Access Compliance Report

Public Rights-of-Way

(Curb Ramps)

Intersection ID: N/A	Main Street: SPRATT_ST	Cross Street: N/A	Location: NW
ADA ID: B83F2572B49C	Ramp Type: Perp	Initial Pass/Fail: Fail	Overall Compliance: No
Severity Score: 12.5			
Codes/Mitigation Info/Possible Solution		Field Measurements/Component Compliance

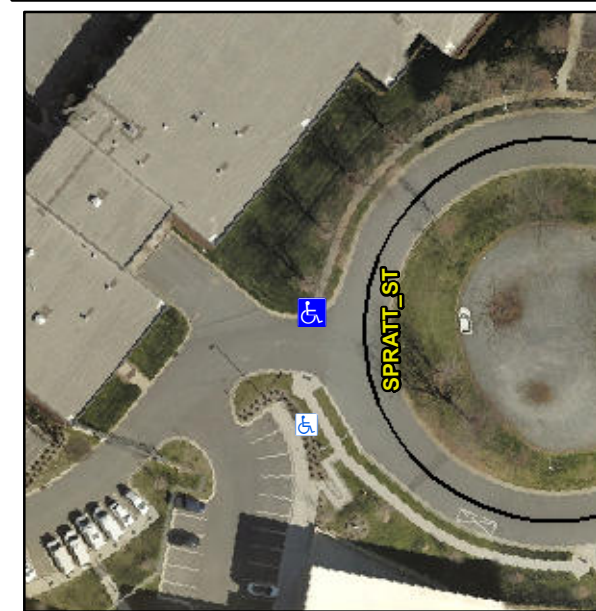
Not Found, R304.2.2

Compliance	Description	Data	Compliance	Description	Data
N/A	Ramp Length (in)	43.0	No	Ramp Slope (%)	9.8
Yes	Ramp Width (in)	48.0	Yes	Ramp XSlope (%)	1.2
N/A	Flare Type LT	N/A	N/A	Flare Type RT	N/A
N/A	Flare Slope LT (%)	N/A	N/A	Flare Slope RT (%)	N/A
N/A	Flare Traversable LT?	N/A	N/A	Flare Traversable RT?	N/A
N/A	Landing Length (in)	N/A	N/A	DWS Provided?	N/A
N/A	Landing Width (in)	N/A	N/A	DWS Contrast?	N/A
N/A	Landing Slope (%)	N/A	N/A	DWS Length (in)	N/A
N/A	Landing X Slope (%)	N/A	N/A	DWS Full Width?	N/A
N/A	Landing Curb? (Y/N)	N/A	N/A	DWS Offset (in)	N/A
N/A	Shared Landing?	N/A			
N/A	Gutter Ponding?	N/A	N/A	Gutter Slope (%)	N/A
N/A	Gutter Lip Ht (in)	N/A	N/A	Gutter X Slope (%)	N/A
N/A	Painted X Walk1?	No	N/A	Painted X Walk2?	N/A
	X Walk 1 Direction	To S		X Walk 2 Direction	N/A
N/A	X Walk 1 Width (in)	N/A	N/A	X Walk 2 Width (in)	N/A
	X Walk 1 Slope (%)	2.1		X Walk 2 Slope (%)	N/A
	X Walk 1 X Slope (%)	5.8		X Walk 2 X Slope (%)	N/A

Remove & Replace Entire Ramp.
